Re: PUC Project No. 55718, *Reliability Plan for the Permian Basin under PURA § 39.167*

ERCOT Permian Basin Reliability Plan Study - Addendum

Addendum

Figure 1.2: Modified 345-kV Import Paths in 2038

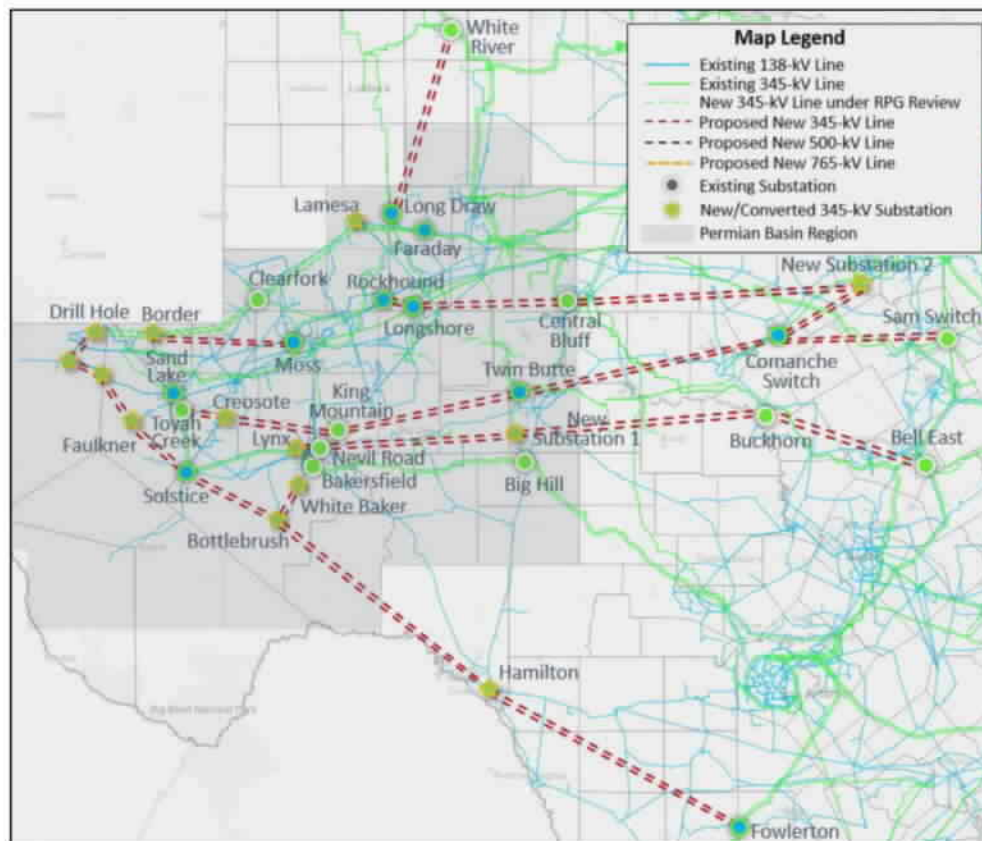
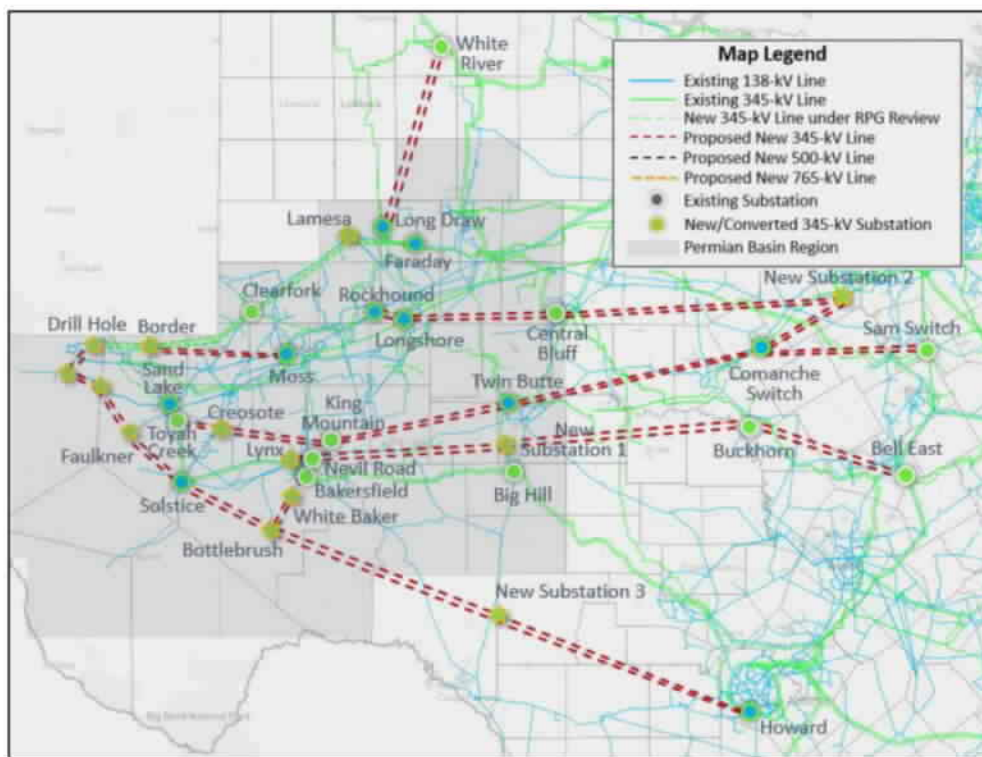
ERCOT is submitting this addendum to the Reliability Plan for the Permian Basin Region to change the recommended endpoint of one of the 345-kV import paths, Import Path 4. Specifically, ERCOT now recommends that this Import Path 4 should terminate at Howard 345-kV instead of Fowlerton 345-kV. This change will require the addition of a new 345-kV substation—"New Substation 3"—in place of the proposed new Hamilton 345-kV substation. ERCOT is recommending this change to the endpoint of Import Path 4 to better accommodate the changing load and generation patterns across the larger system, as identified in the initial 2024 Regional Transmission Plan (RTP). ERCOT has conducted additional reliability assessments consistent with the methodology identified in the Permian Basin Reliability Plan Study and confirmed that the proposed new endpoint to Import Path 4 meets the overall reliability need and performance of the 345-kV import path in the Permian Basin Reliability Plan Study. Figure 1.1 shows the original proposed 345-kV import paths for 2038, and Figure 1.2 shows the modified 345-kV import paths for 2038.

Modified Import Path 4:

- Construct a new 345-kV "New Substation 3" substation. Add new dynamic reactive devices (350 MVar) at New Substation 3 345-kV substation; and
- Add new Howard – New Substation 3 – Bottlebrush – Solstice 345-kV double-circuit lines with a normal and emergency rating of at least 2988 MVA per circuit. This will require approximately 370 miles of new right of way (ROW).
